# Work Order ID 86950

Item Name: 205 Skidtube bent detail

DRAWING NO. D2580	TITLE 205 SKIDTUBE ASSEMBLY	REV. E	DART AEROSPACE LTD ENGINEERING ORDER		D.E.O. NO. D2580-E-1	SHEET NO. SHEET 1 OF 1	SCALE NTS
DRAWN <i>UP</i>	CHECKED <i>ASS</i>	MFG. APPR. <i>ER</i>	APPROVED <i>#</i>		DE APPR. <i>HA</i>		
DATE 11.12.13	DATE 11.12.13	DATE 11.12.13	DATE 11.12.13		DATE 11.12.13

CHANGE ALL C'BORED WELDED CROSSBOLT SPACERS TO SWAGED SPACERS.

**SECTION B-B, F-F, I-I**  
NOT TO SCALE

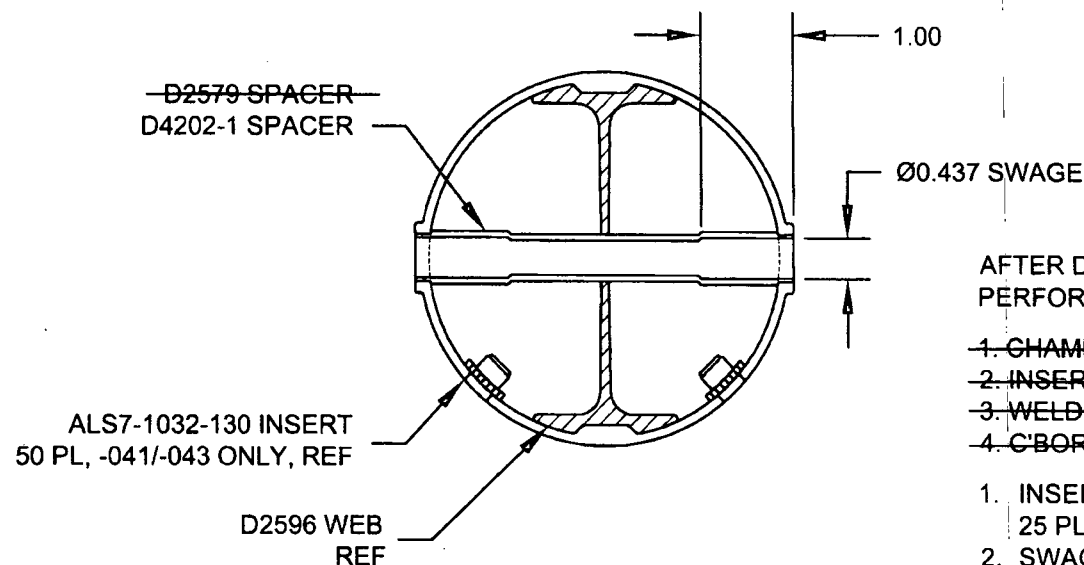
PARTS LIST IS AMENDED AS FOLLOWS:

QTY	QTY	QTY	PART NUMBER	DESCRIPTION
-041	-045	-047		
20	24	25	D2579	CROSS BOLT SPACER

SECTION B-B, SECTION F-F, & SECTION I-I ARE AMENDED AS FOLLOWS FOR ALL HOLES THAT WERE ORIGINALLY C'BORED:

1. CHAMFER HOLE 0.050 X 45°
2. INSERT D2579 SPACER (20 PLACES)
3. WELD INTO PLACE AND GRIND FLUSH
4. C'BORE D2579 SPACER TO Ø0.437 X 1.00 DEEP

4		* D2579	CROSS BOLT SPACER
20	20	25	D4202-1	SPACER

WELD 4X D2579 SPACERS PER DWG IN LOCATIONS MARKED "NO C'BORE".  
REF SHEET 4 OF DWG.

1. INSERT D4202-1 SPACER, 20 PL (-041) OR 20 PL (-045) OR 25 PL (-047)
2. SWAGE TO Ø0.437 X 1.00 DEEP PER QSI 002
3. TRIM / GRIND FLUSH PER QSI 002
